CEMINDIA PROJECTS LTD.

ARCHITECTURAL / FINISHING WORKS FOR LIGHT HOUSE UNDER GROUND STATION

TENDER No. – 01-AT-052022-C4-UG01-SC_ARC–LH

ADDENDUM No. – 1

DRAWING NUMBER P20C40UG01TYP-MMSO-ARCGENDWG-00009(2)

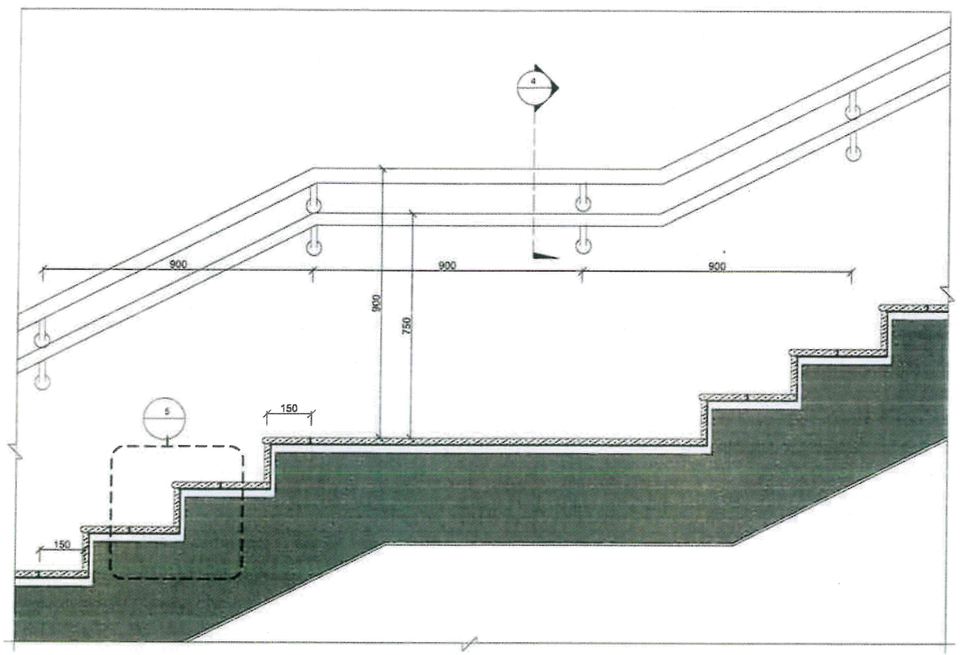
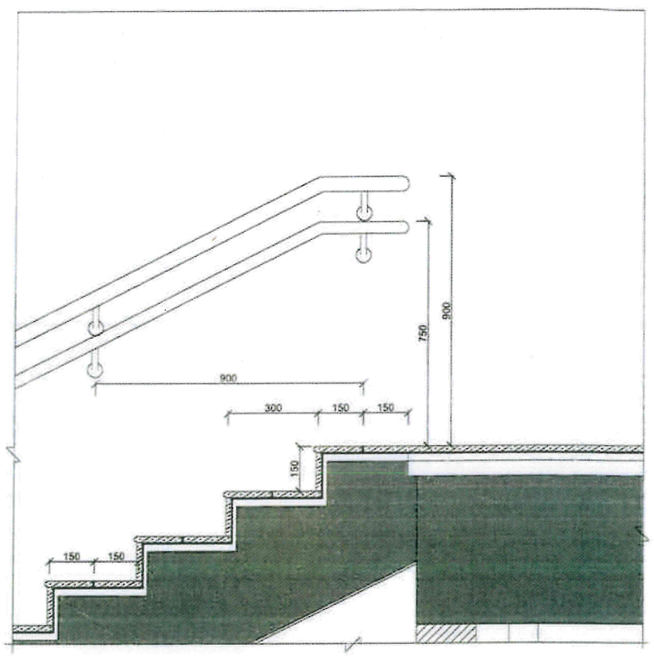
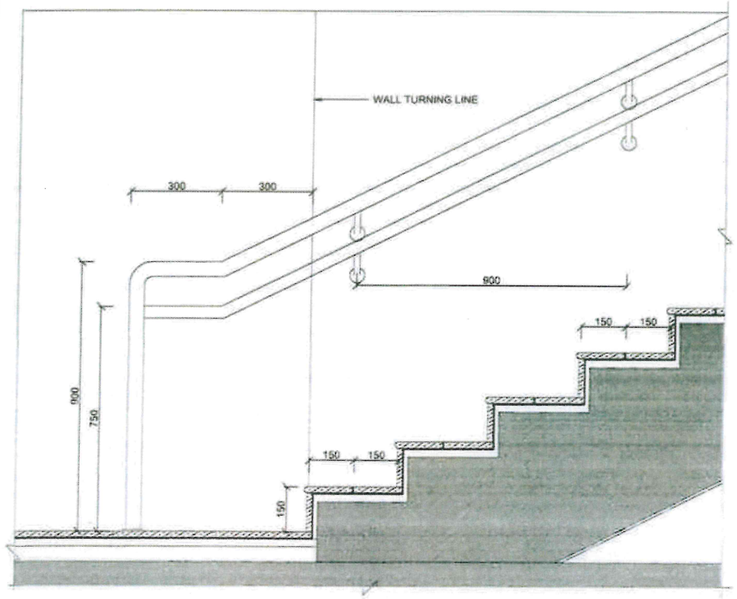
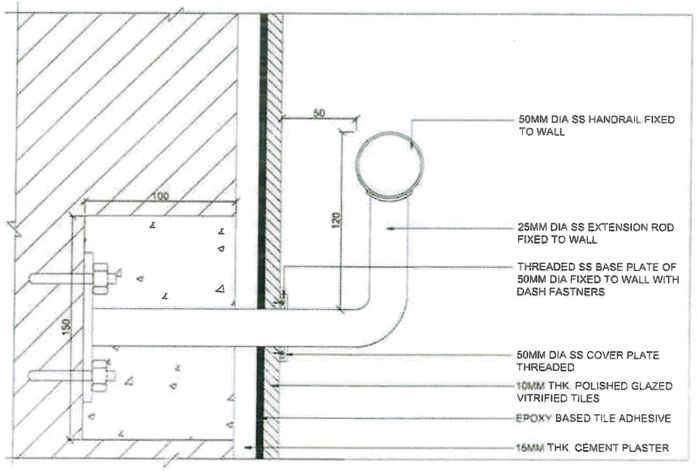
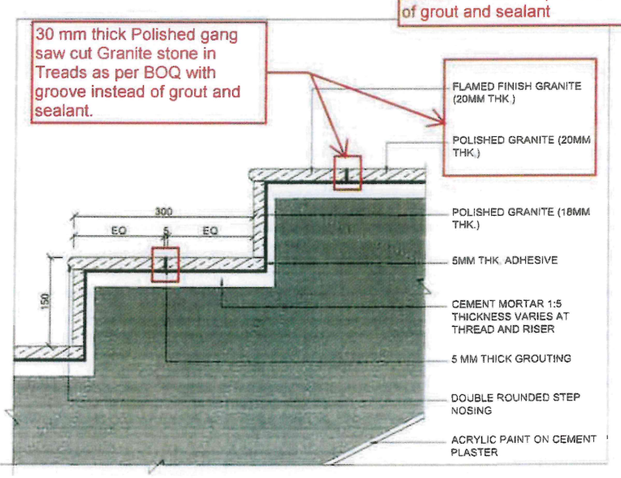
30 mm thick Polished gang saw cut Granite stone in Treads as pr BOQ with groove instead of grout and sealant

30 mm thick Polished gang saw cut Granite stone in Treads as per BOQ with groove instead of grout and sealant.

10 mm thick granite as per BOQ for the riser.

DRAWING NUMBER: P20C40UG01TYP-MMSO-ARCGENDWG-00010(2)
SCALE: AS SHOWN
REV: 02

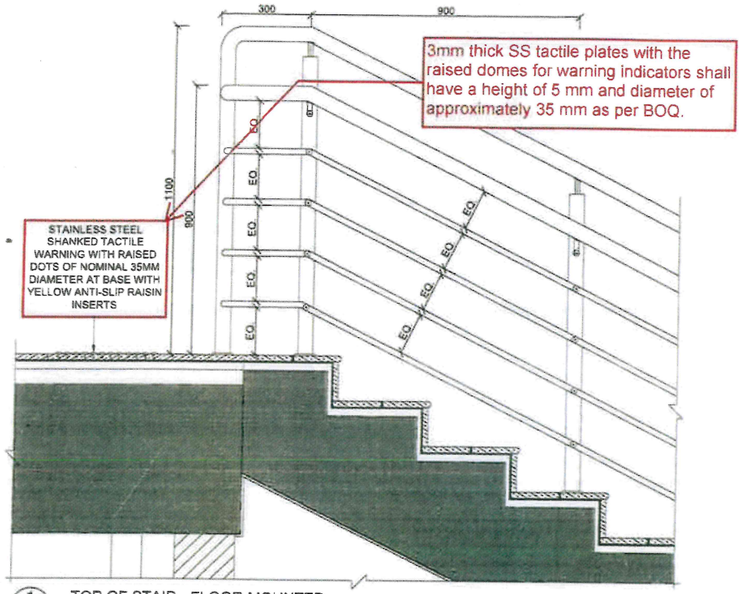
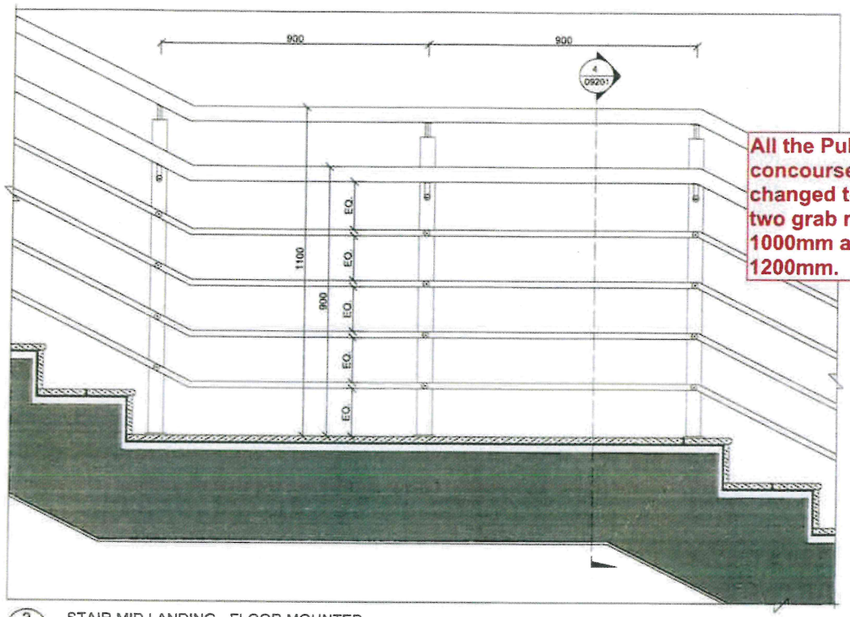
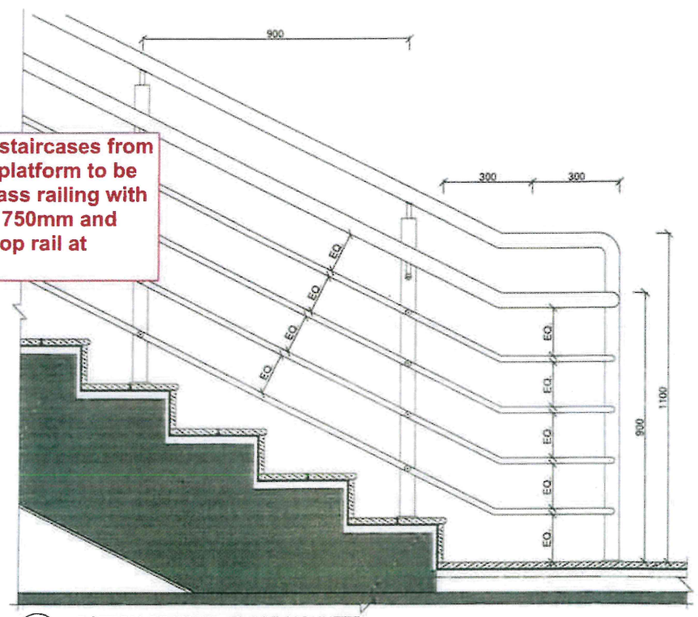
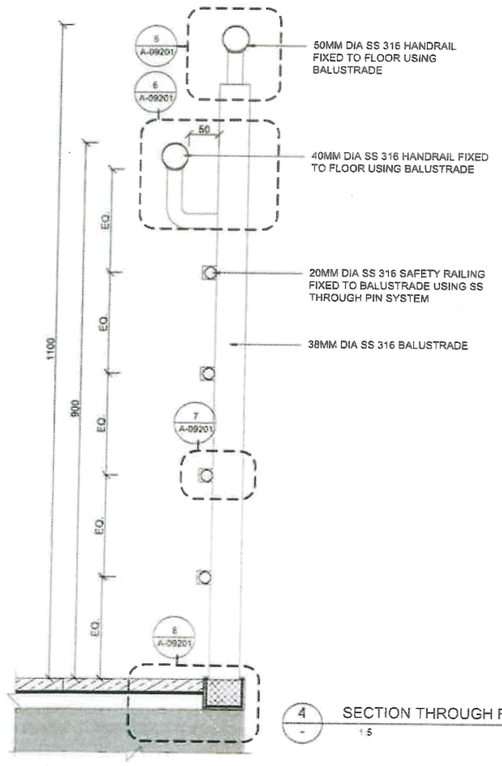
All the Public staircases from concourse to platform to be changed to glass railing with two grab rails 750mm and 1000mm and top rail at 1200mm.

NOTE : THE GAP BETWEEN TWO HORIZONTAL SS SAFETY RAILING MEMBERS SHOULD NOT EXCEED 150MM. THIS NEEDS TO BE FOLLOWED AT ALL LOCATIONS.

DRAWING NUMBER
P20C40UG01TYP-MMSO-ARCGENDWG-00017(1)

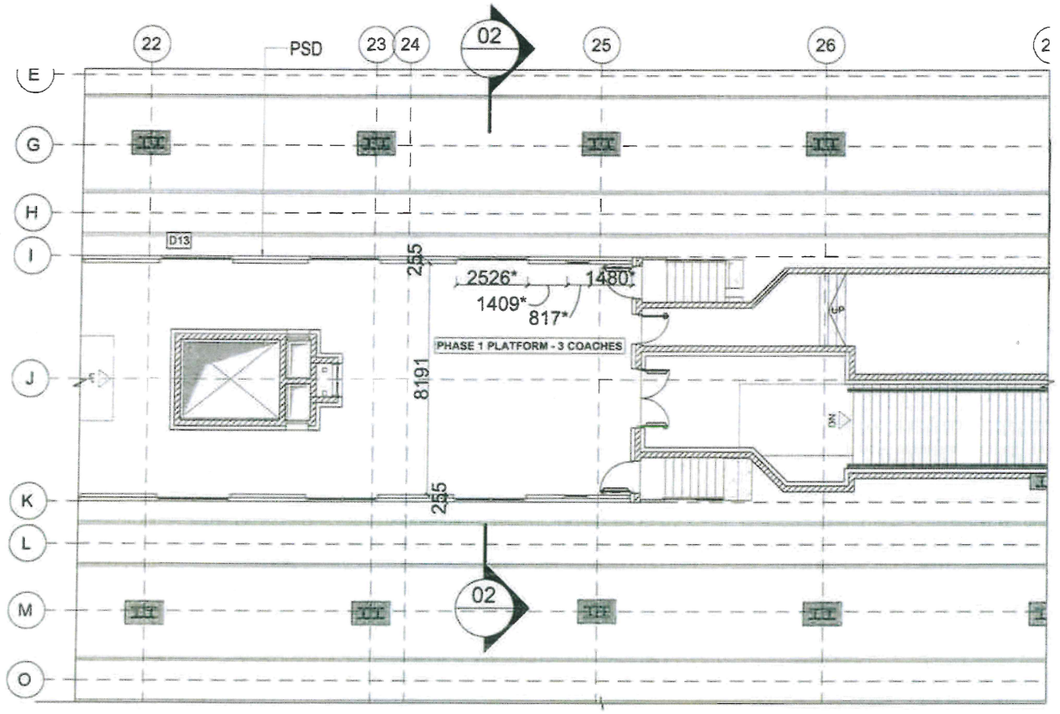
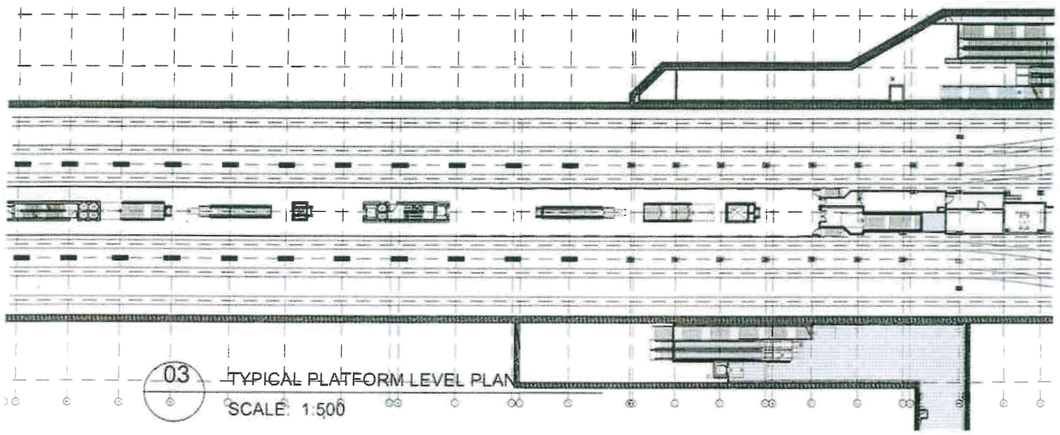
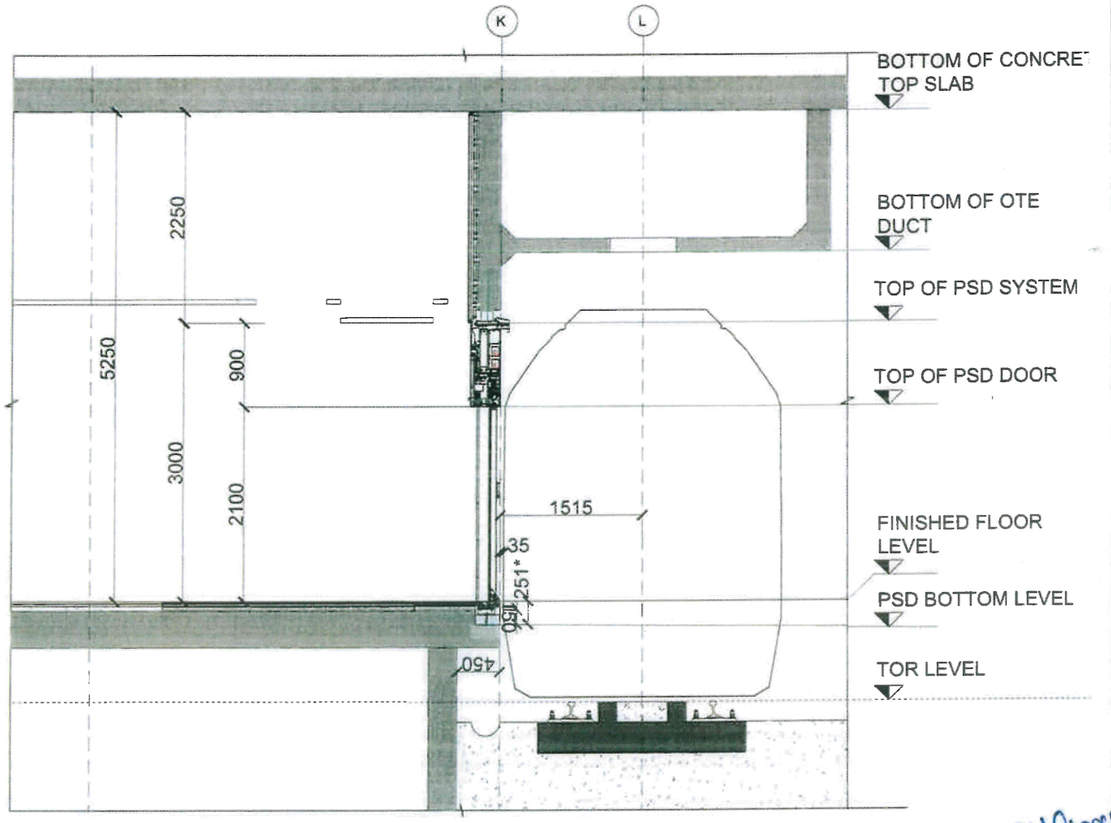
PHASE 2 PLATFORM (6 COACHES)
THE PSD DOOR OF 6 COACH PORTION SHALL BE FIXED GLASS INSTEAD OF THE PSD SLIDING DOOR.
